Minutes of the Regular Meeting of the Albany County Airport Authority

September 15, 2025

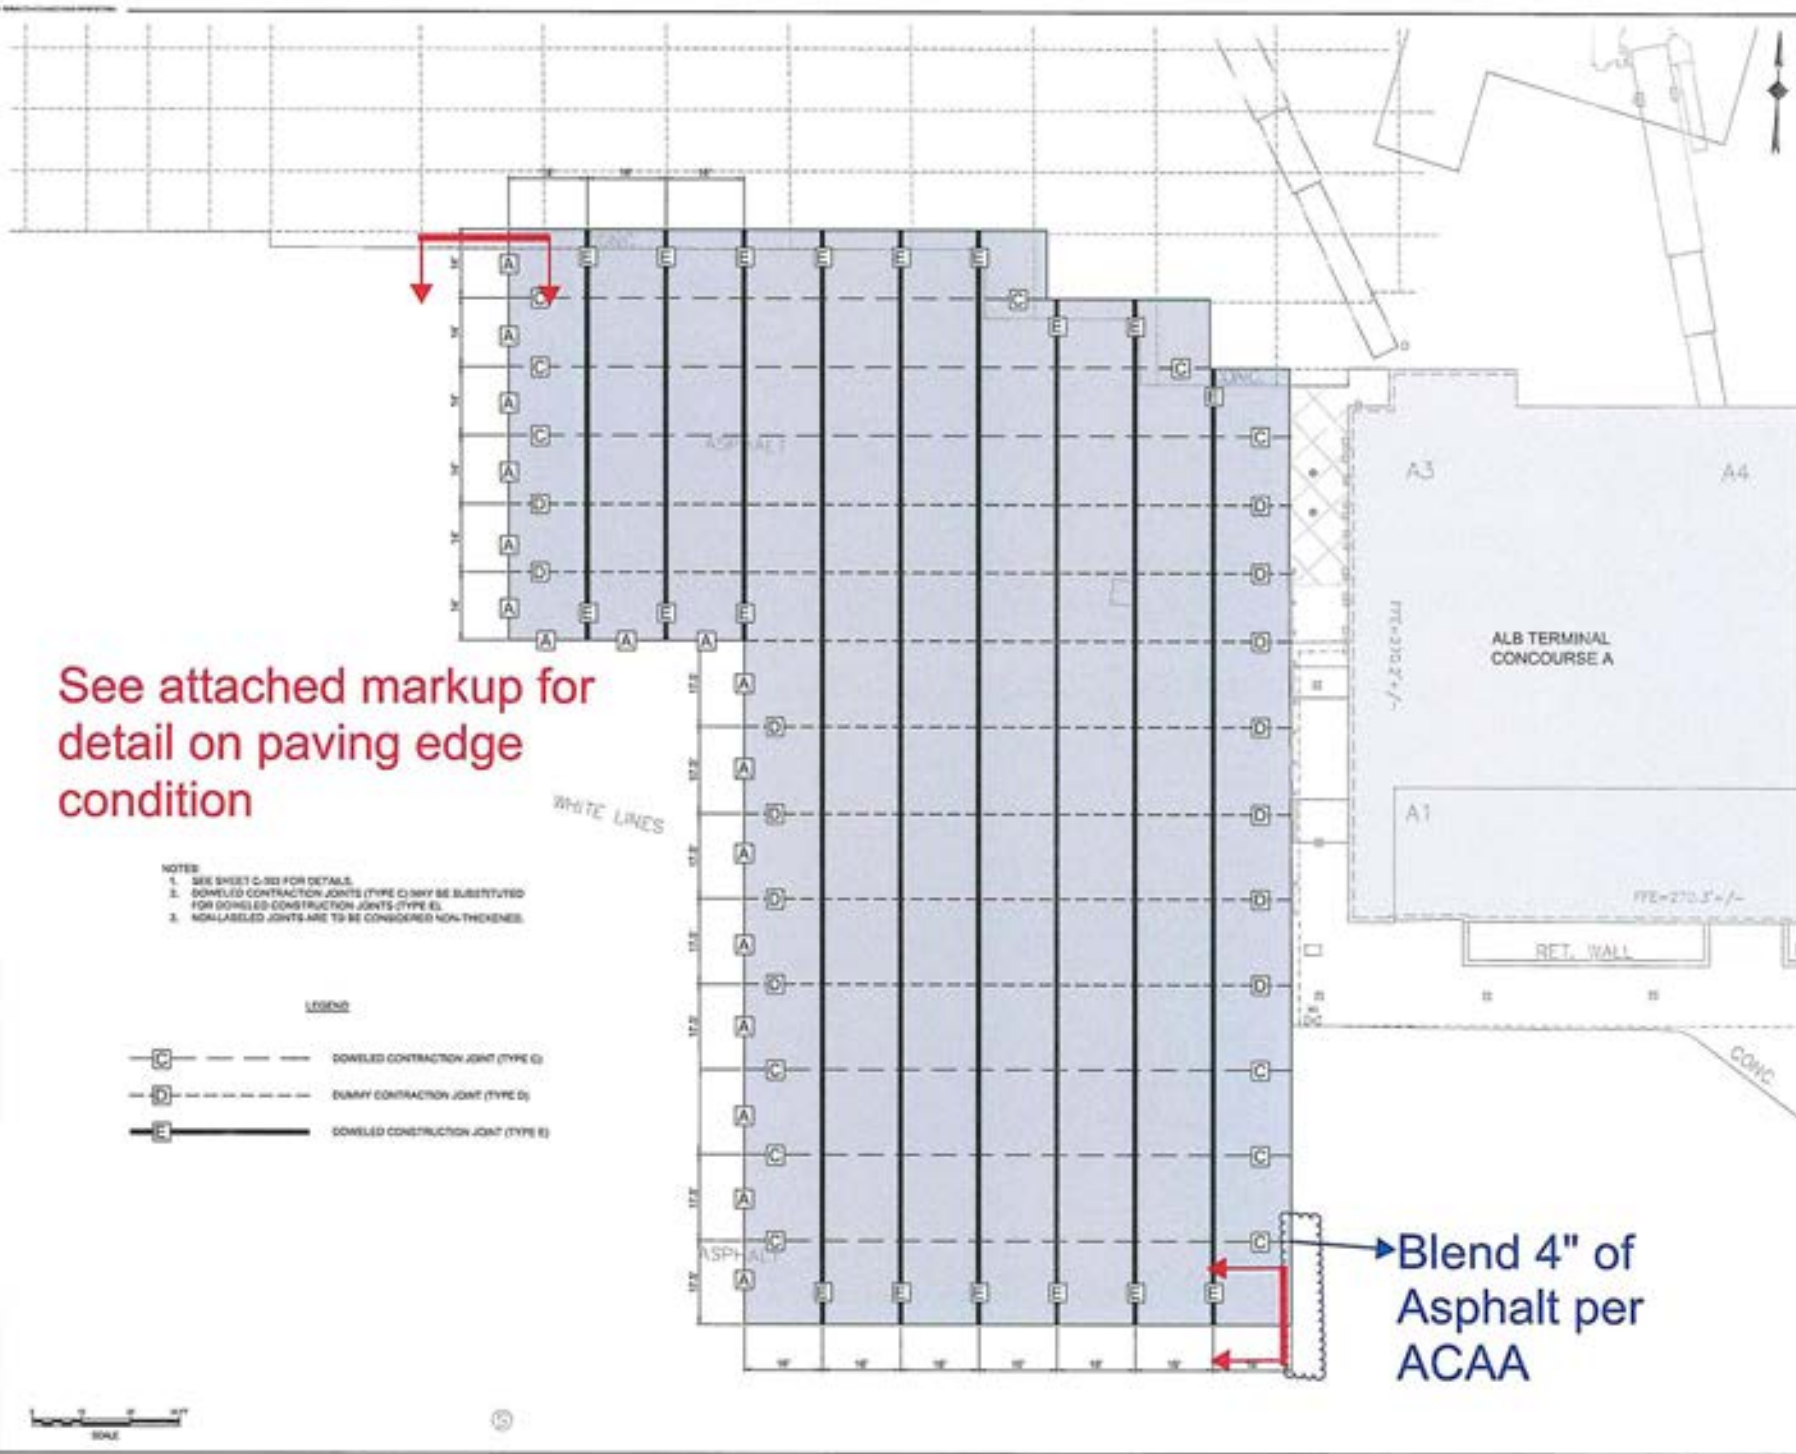
Question	<p><i>Question from Alysia Sanichar AOW Construction on Wednesday, Mar 19, 2025 at 01:18 PM EDT</i></p> <p>The concrete paving elevations do not align flush with the existing paving. Please advise how to tie the two elevations together. Attached survey provides the elevations of the concrete paving and elevations for the asphalt paving at 2'-0" and 10'-0" offsets.</p> <p>Attachments CONCRETE PAVEMENT TIE IN.pdf</p>
Official Response	<p><i>Response from Turner Bradford, PE McFarland-Johnson Inc on Tuesday, Apr 8, 2025 at 02:56 PM EDT</i></p> <p>We take no exception to the proposed detail, with the caveat that existing asphalt to remain will be saw cut to create a clean edge and all joints will be sawed and sealed in accordance with specification P-605.</p>
Official Response	<p><i>Response from Brian McNeil Turner Construction Company on Monday, Apr 7, 2025 at 04:17 PM EDT</i></p> <p>Per our pre-paving meeting and discussion with ACAA, please see attached detail. Please place 4" of new asphalt with a tack coat at 2". ACAA requests to blend asphalt at specified area in the attached markup.</p> <p>Attachments RFI-110 Markup Detail.pdf</p>

See attached markup for detail on paving edge condition

We take no exception to the proposed detail, with the caveat that existing asphalt to remain will be saw cut to create a clean edge and all joints will be sawed and sealed in accordance with specification P-605.

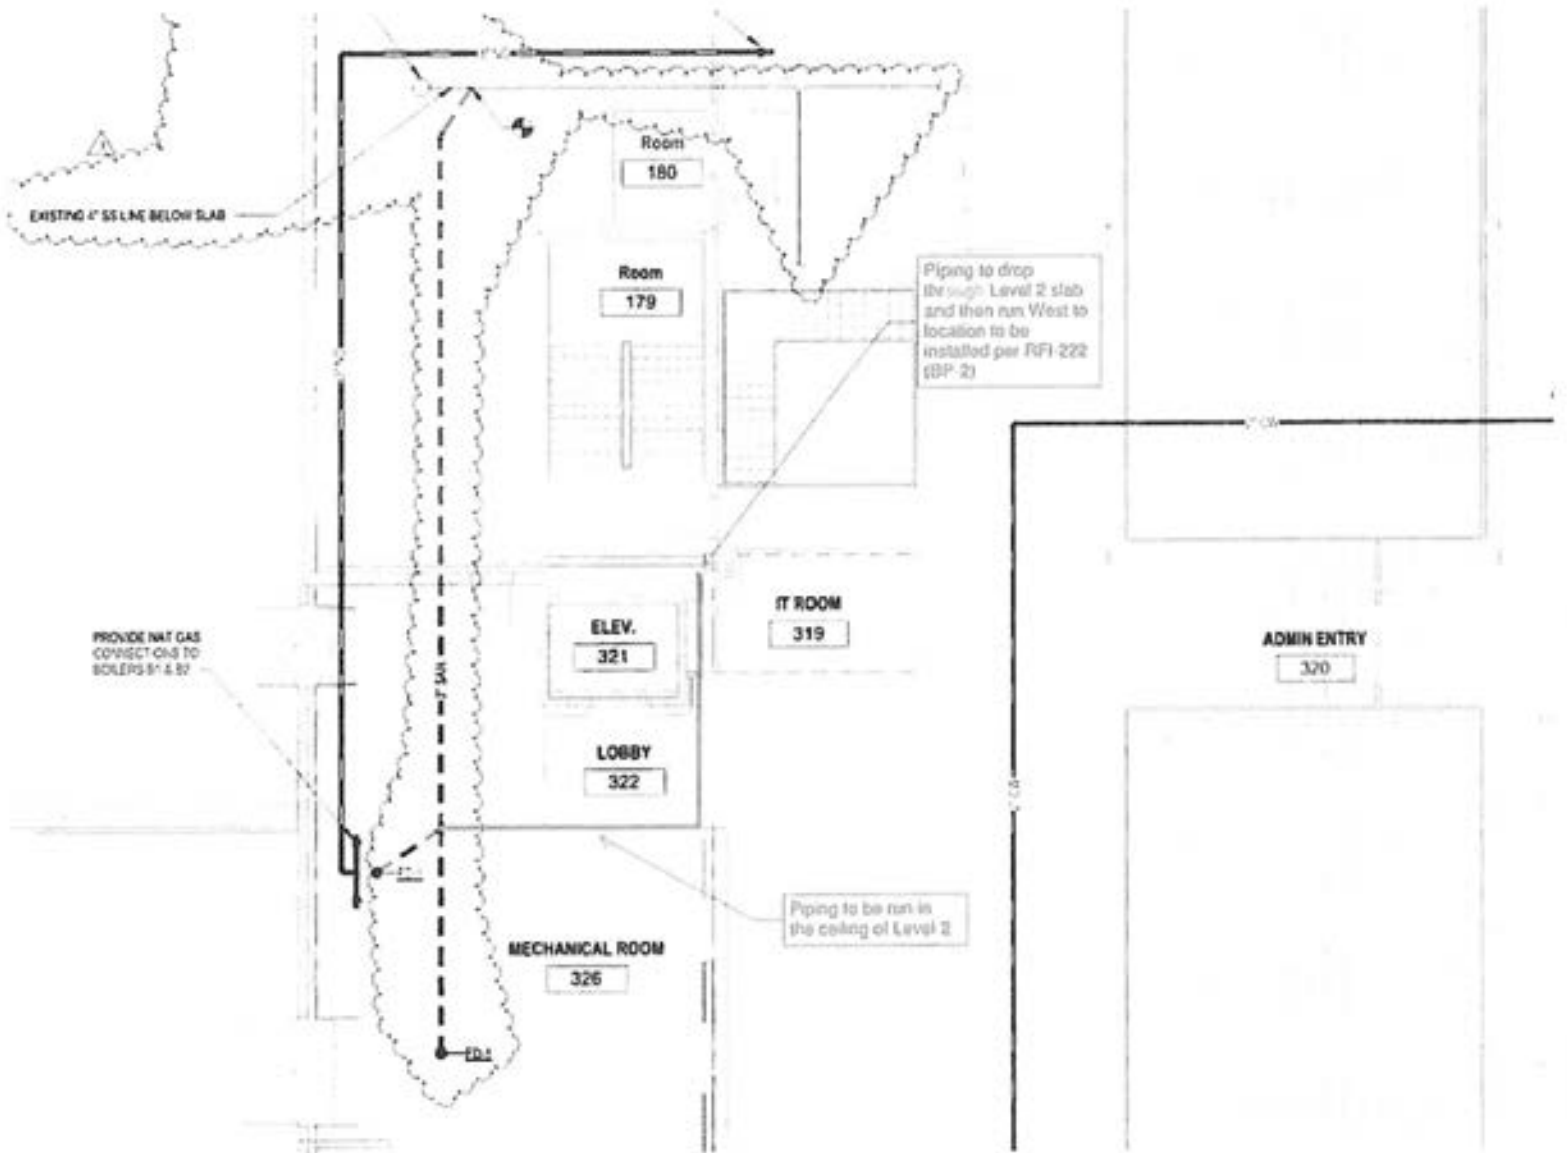
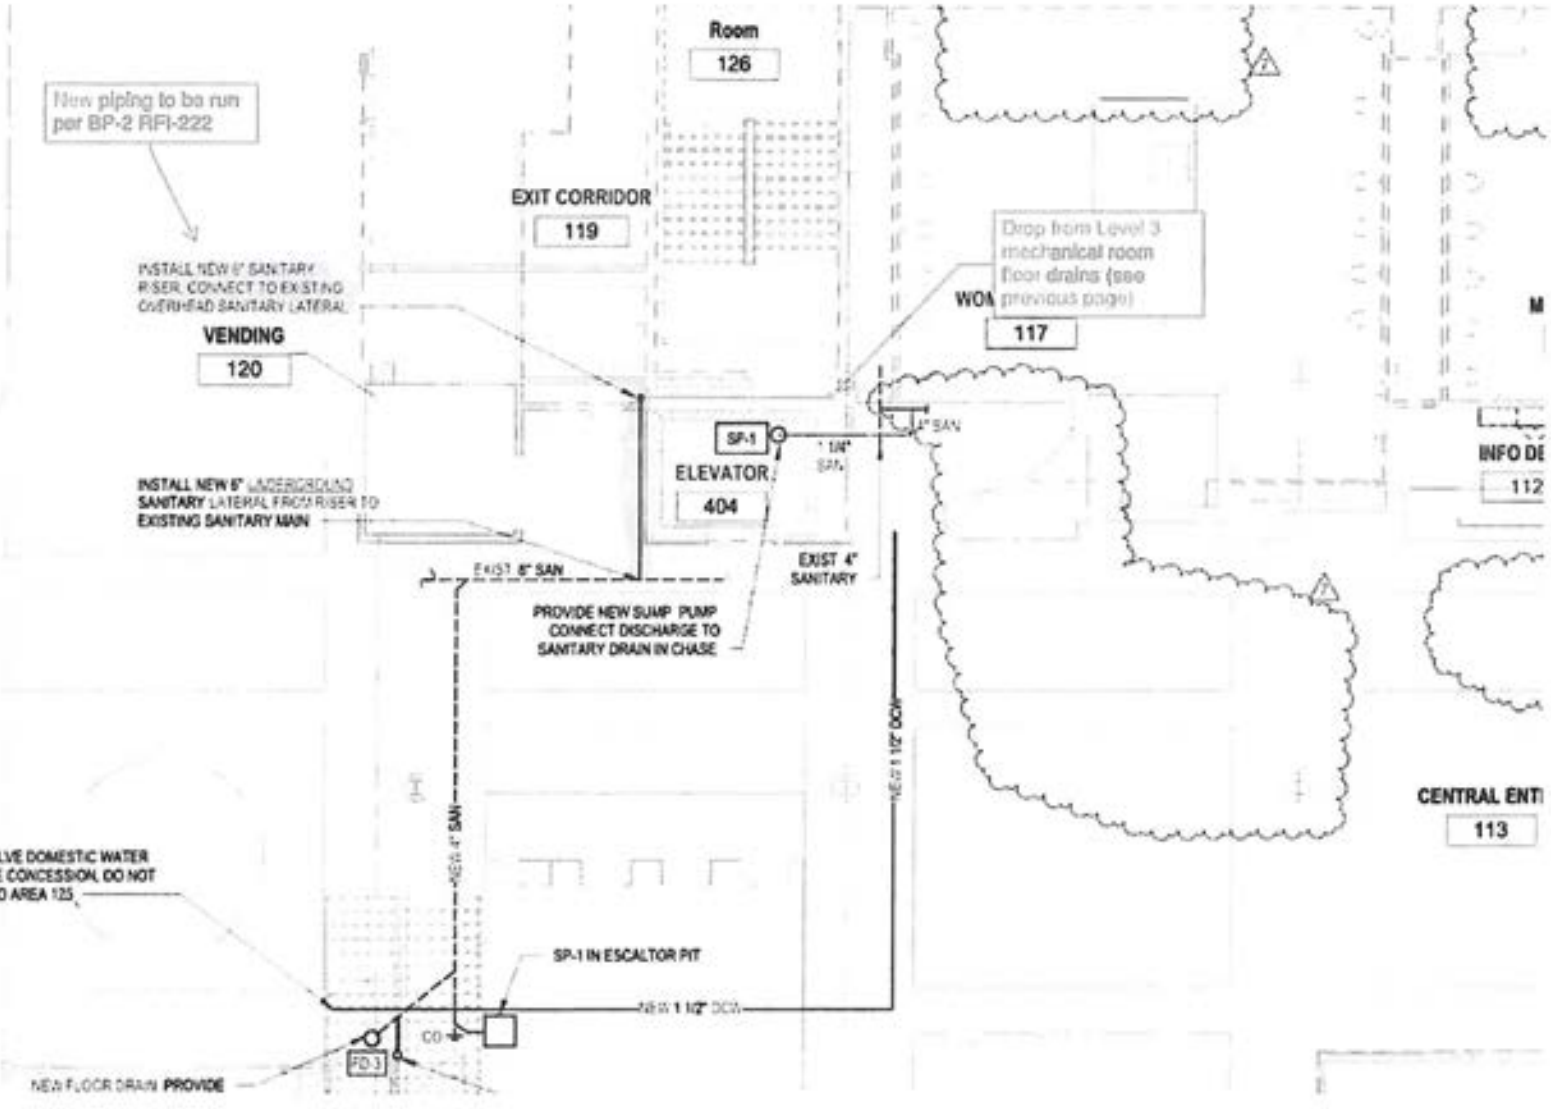
The floor drain routing shown per ASI-107 is not feasible due to the length of the run, pitch required, and the existing conditions that are present beyond C-Line. Danforth would like to utilize a route similar to that shown in the attached. Please advise if this is acceptable and/or revise as necessary.

HS-11
SECOND LEVEL FLOOR PLAN
AREA "B" - FIRE PROTECTION
E.C. Lee

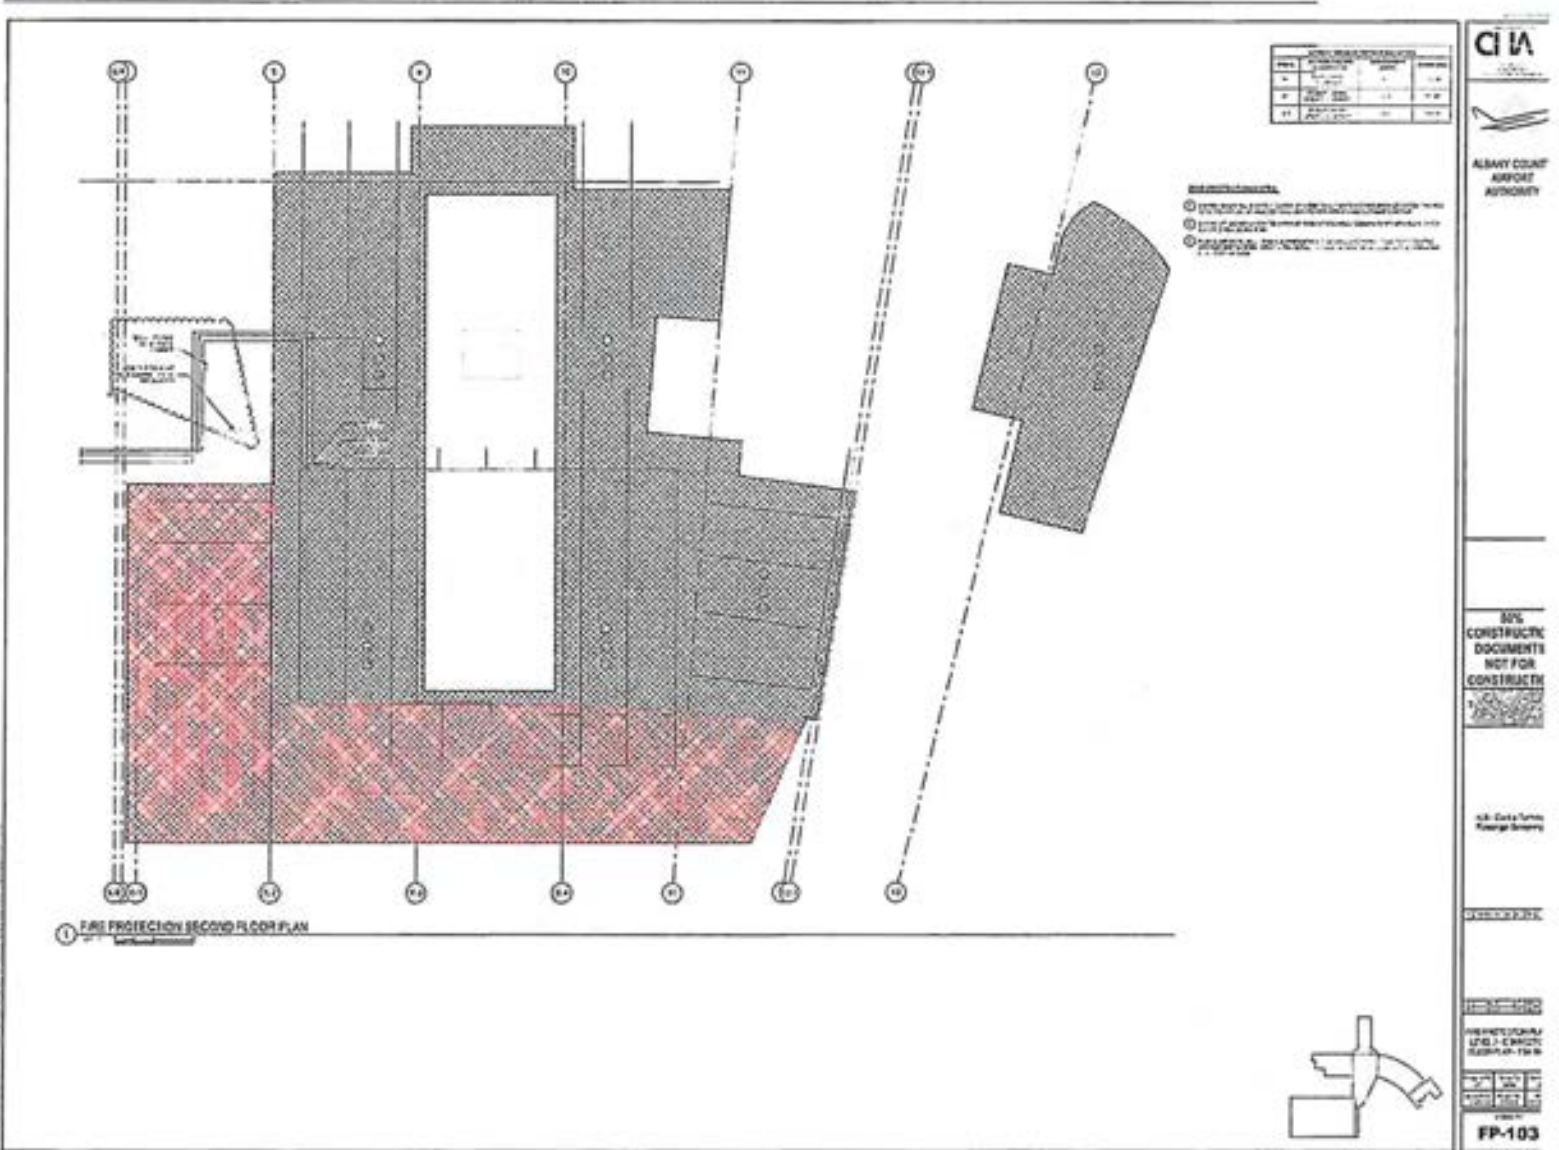
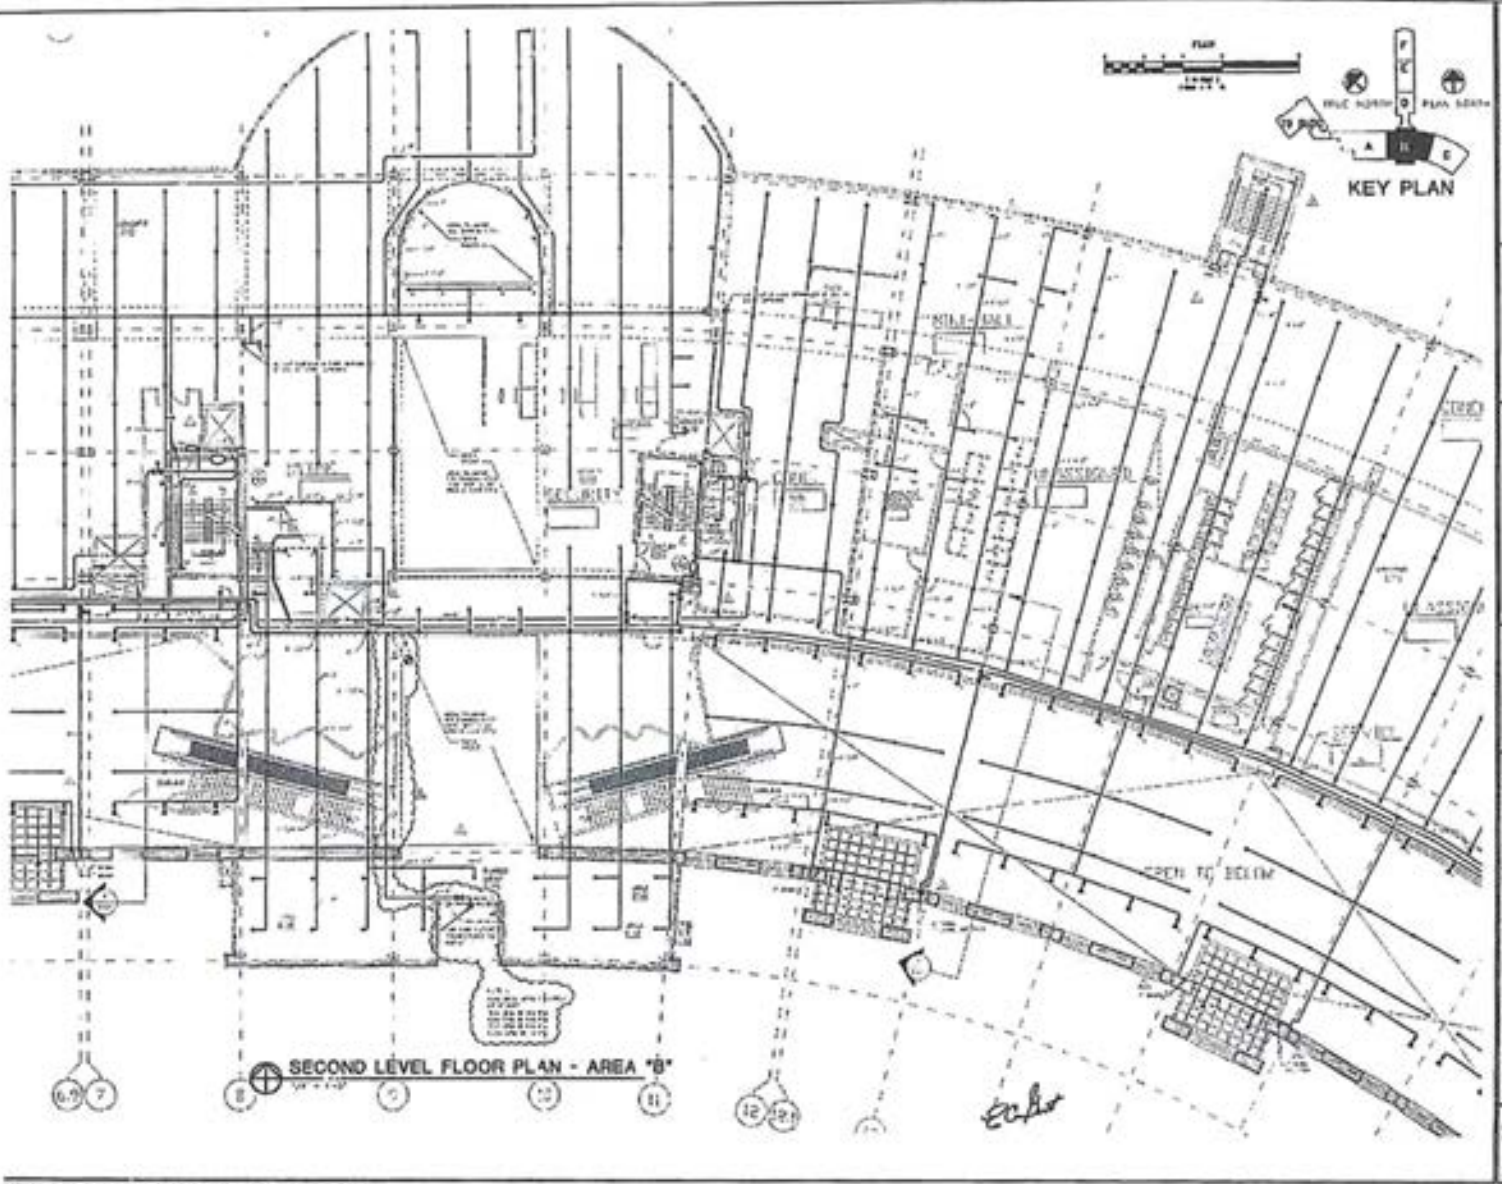
See attached mark-up. As discussed with TCCo previously, the sprinkler system in the shaded area was required to be removed A.) Due to the fact that demolition ultimately rendered this WET system to be outside where it was subject to freezing and B.) Due to the fact that it's presence would have impeded the installation of steel.

Demo'd wet system lines are to be reconstructed in their previous locations. See record drawing F-106 for locations and pipe sizes.
